AGENDA
CITY OF KENTWOOD PLANNING COMMISSION
TUESDAY, DECEMBER 13, 2022
KENTWOOD COMMISSION CHAMBERS
4900 BRETON AVENUE
7:00 P.M.

STAFF REPORT: December 6, 2022
PREPARED FOR: Kentwood Planning Commission
PREPARED BY: Lisa Golder
CASE NO.: 1-23 Steelcase PUD Major Change

Case No. 1-23 Steelcase PUD Major Change

Steelcase		TRANSPORT PROPERTIES 9500 W BROADWAY, SUITE 200 WWW.TRANSPORTPROP.COM	
DATE	ISSUE	IPUD AMENDMENT 4308 52ND STREET SE KENTWOOD, MICHIGAN 49512	
11/18/2022	PRELIMINARY PUD SITE PLAN SUBMITTAL		
PRELIMINARY SITE PLAN		11/18/2022	
SP-1

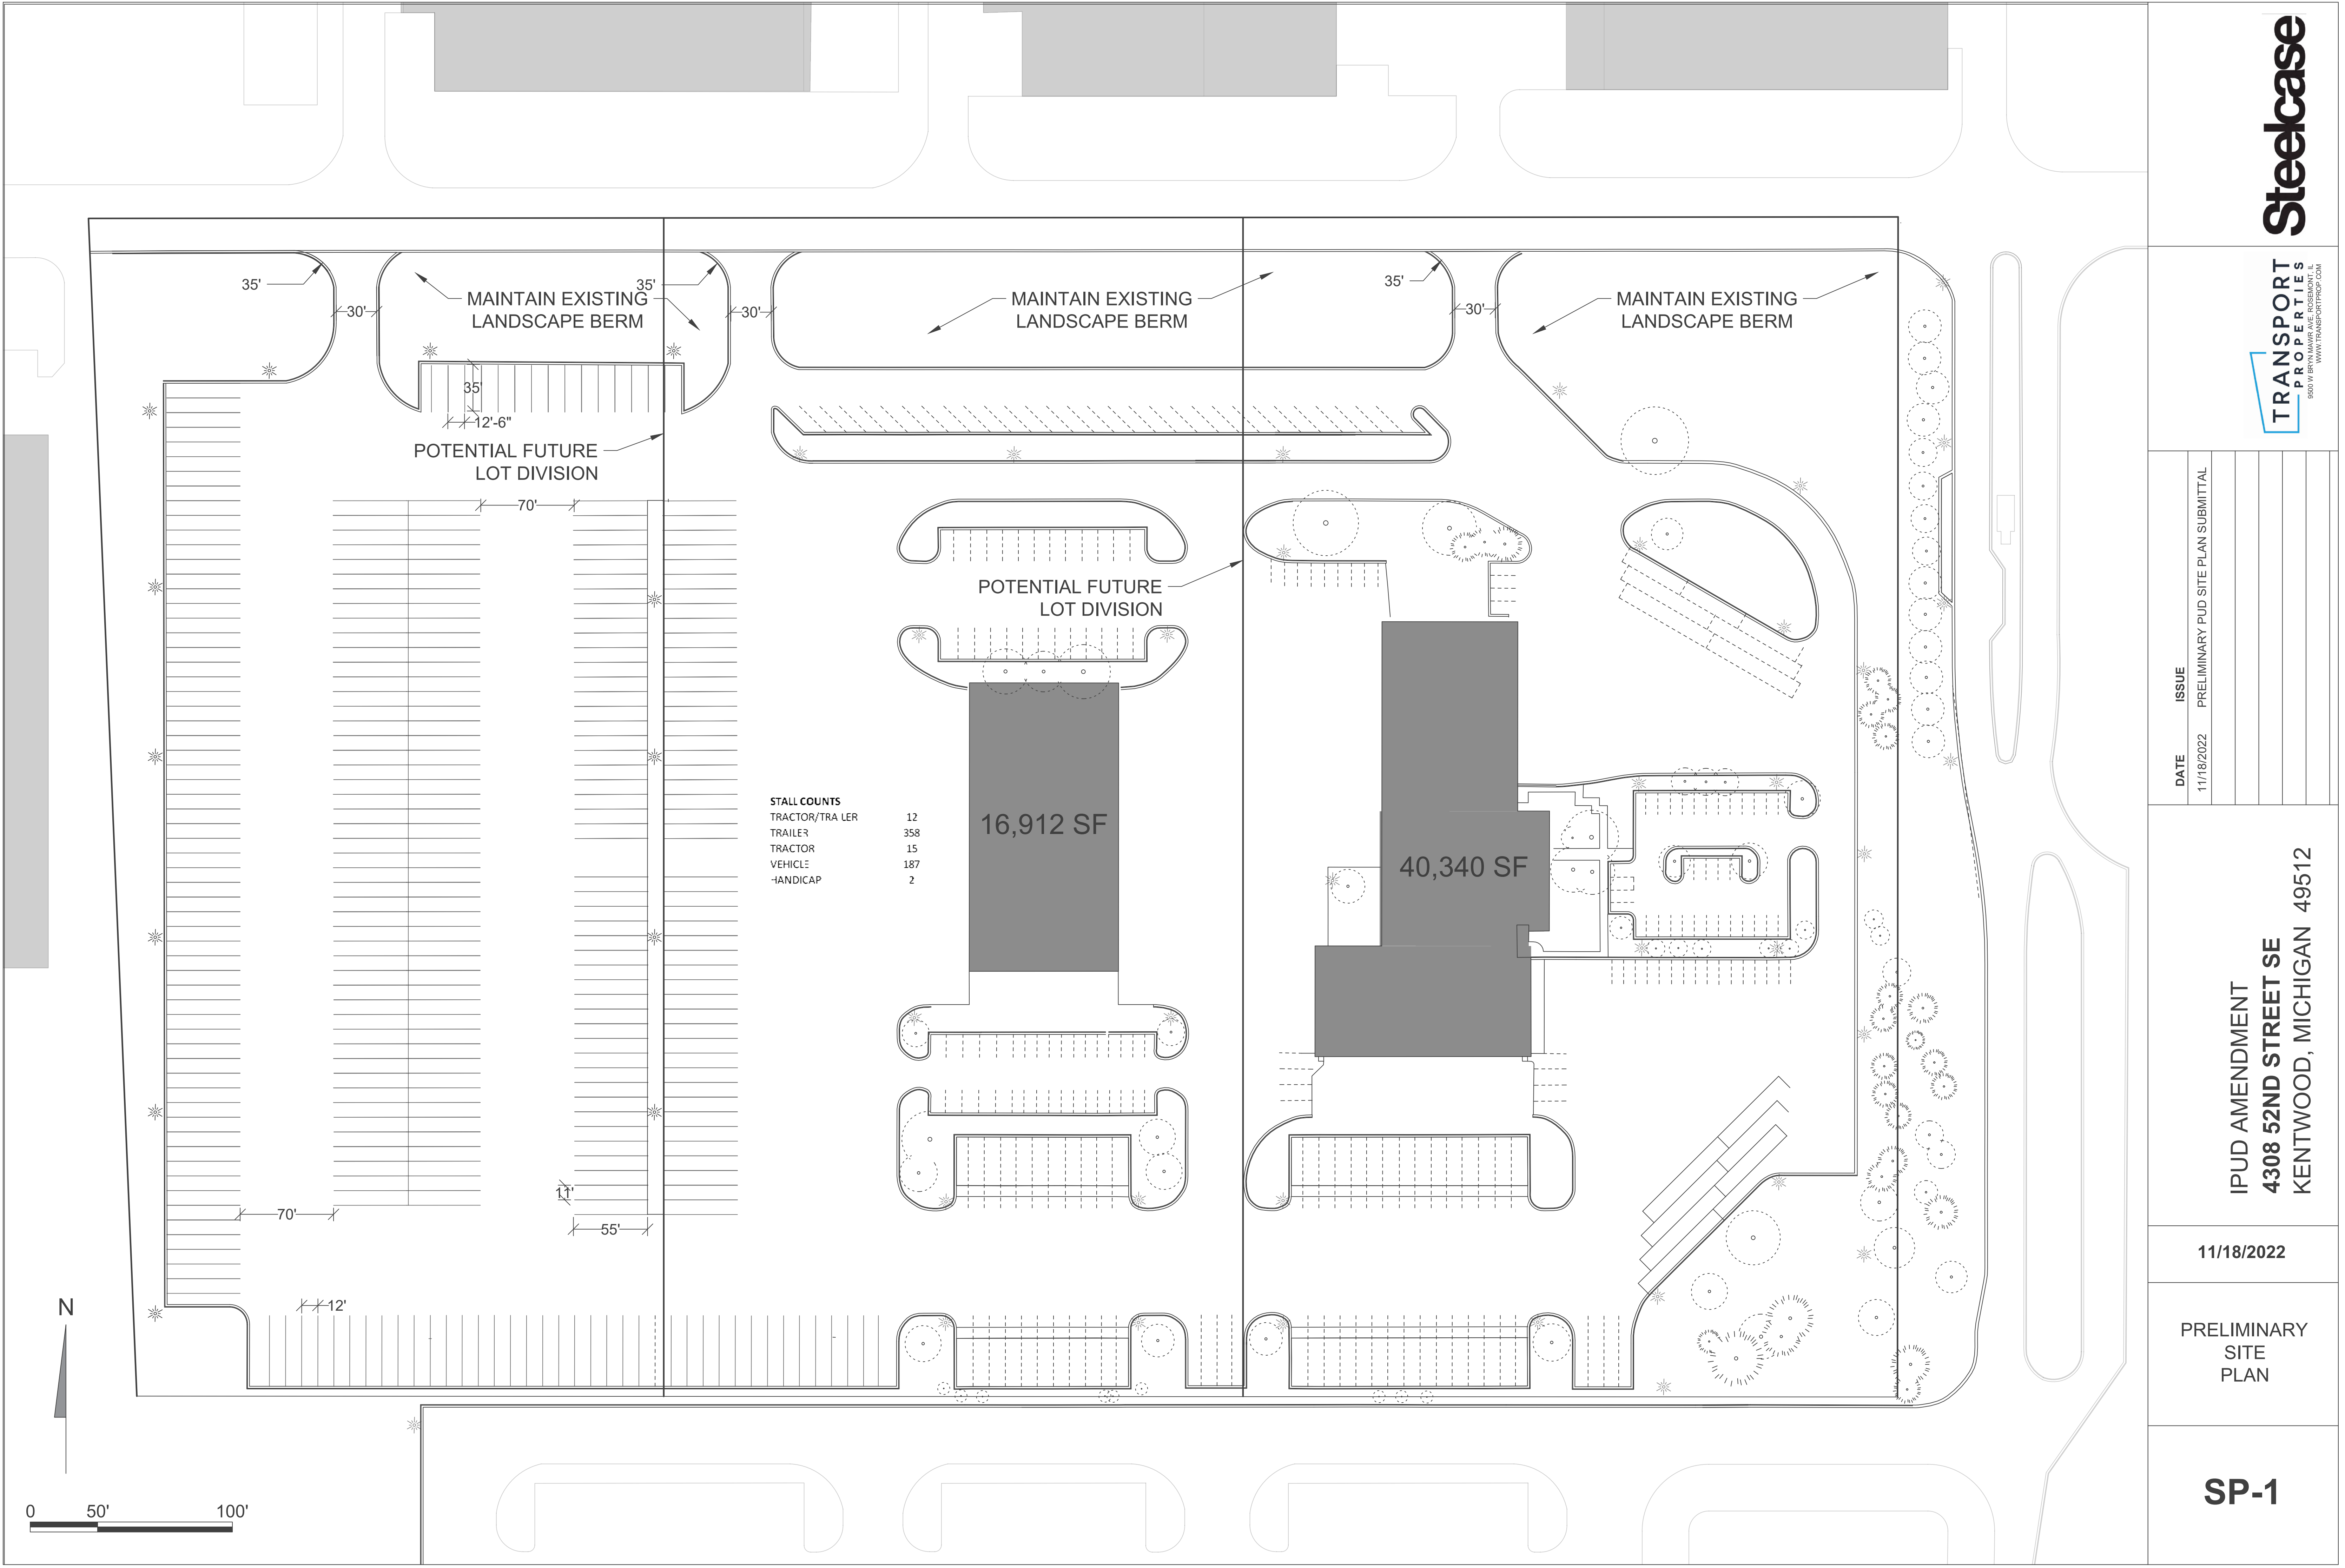
The applicant should provide additional justification for the need for three new curb cuts onto 52nd Street. Alternatively, the applicants could determine whether shared access of the existing driveway North Campus Drive is feasible. This may require the relocation of the existing guard shack on the Steelcase property but may allow for greater flexibility in the future as Steelcase considers the disposition of other land within the PUD.

5. The applicant shows new curb cuts to 52nd Street. If these are approved, significant portions of the existing landscape buffer will be removed. The applicant must provide a landscaping plan as part of the final PUD approval to address these changes.
6. The current PUD Agreement is attached. A new Agreement will need to incorporate any proposed changes to the PUD.

- Need for three curb cuts
- Unclear as to whether the maintenance use is integrated into the overall development
- Detail regarding fencing to separate the Plant K-4 from the 27 acre parcels is unclear.
